PLANNING CONSULTATION RESPONSE

Application No	2026/0425
Proposal	Erection of front and side boundary wall (Retrospective).
Address	11 Hardwick Grove, Dodworth, Barnsley, S75 3SS
Date of Consultation Reply	26 th June 2026
Consultee	Highways DC

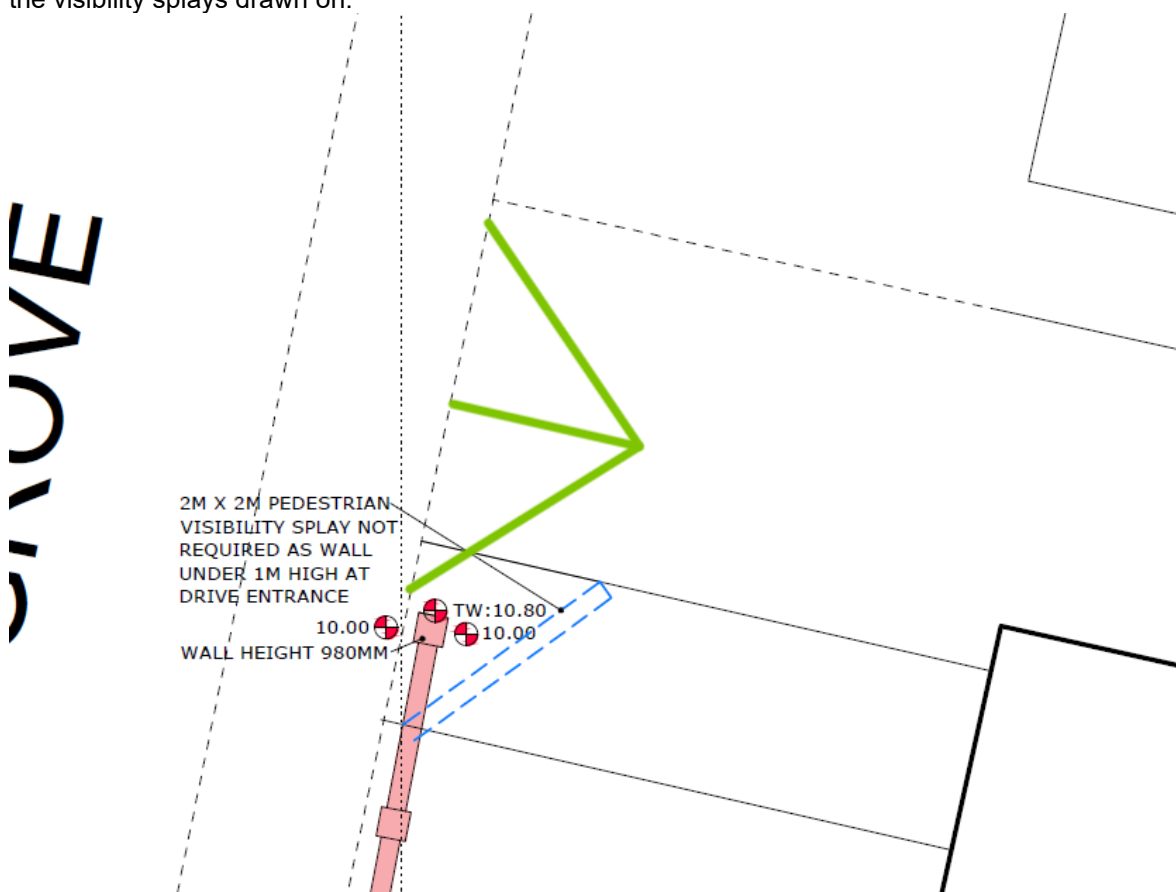
In comparison with the previous application 2026/0102, the submitted details now identify the requirement for the site access to provide 2m x 2m pedestrian visibility splays. However, the site layout plan incorrectly states that the visibility splays are not required because the boundary wall is below 1m in height (980mm) at the driveway entrance. Pedestrian visibility splays are required at a vehicular access onto the public highway regardless of wall height and anything within the 2m x 2m splays cannot exceed 600mm in height. The boundary wall would not necessarily need to be splayed into the site as indicated on the plan, the splays are ordinarily achieved by ensuring that any portion of the boundary wall that falls within the 2m x 2m splays does not exceed 600mm in height.

Notwithstanding the above, now that the position of the wall has been accurately shown on the site layout plan, it is evident that the wall does not actually impede the required 2m x 2m pedestrian visibility splays as can be seen in the image below which is an extract of the site layout plan with the visibility splays drawn on.

The vehicular access shall provide pedestrian visibility splays of 2m x 2m to the back edge of the footway. Nothing shall be erected, retained, planted and/or allowed to grow at or above a height of 0.6m to the rear of the footway which would obstruct the visibility splays. The visibility splays shall be maintained free of obstruction at all times thereafter for the lifetime of the development.
